4kOpen Board HW Recommendation note

Noise suppression on analog audio output

Figure 2: Correction on B2264B to remove noise on audio output

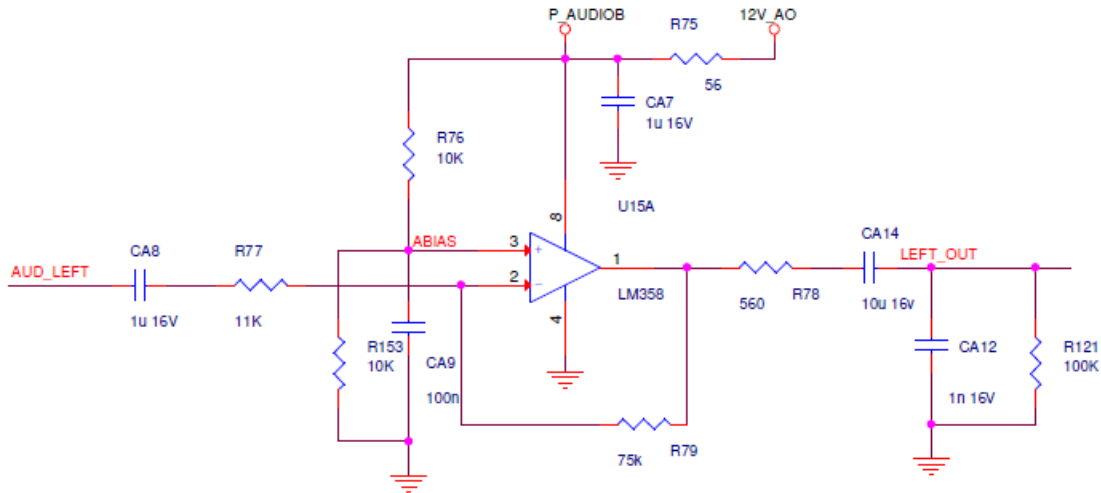
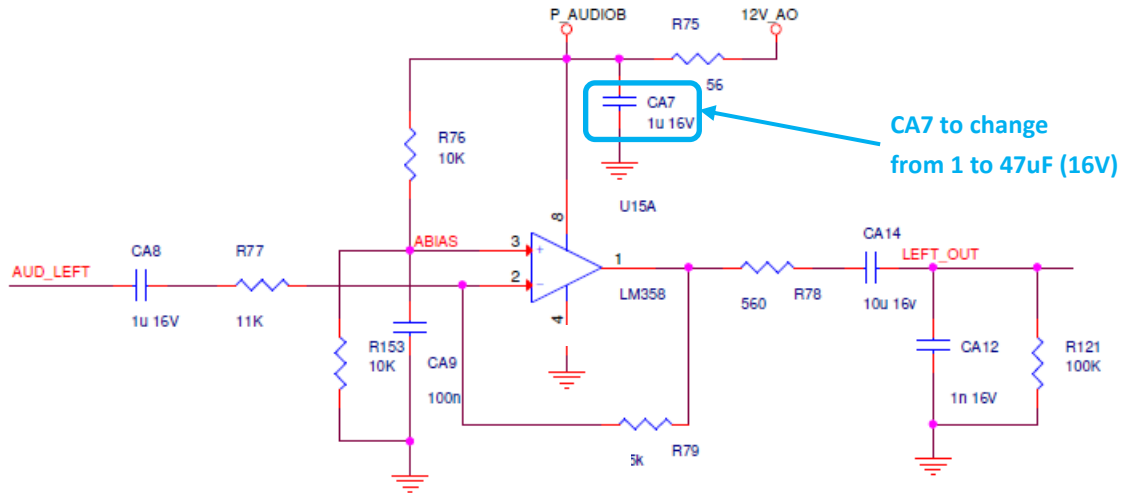
The audio amplifier is supplied by the 12V_A0 signal.

The power filtering of the audio amplifier R75 (56 Ohm) and CA7 (1uF) correspond to a cut off frequency of 2.8KHz. This value is too high.

Thus, any voltage ripple in the audio frequency range on the 12V_A0 supply is also present on the amplifier output.

To remove the noise on the audio output, the cut off frequency of the filter on the audio amplifier must be reduced down to 60 Hz. This means to change the value of CA7 from 1 to 47uF (16V) as depicted on Figure 2
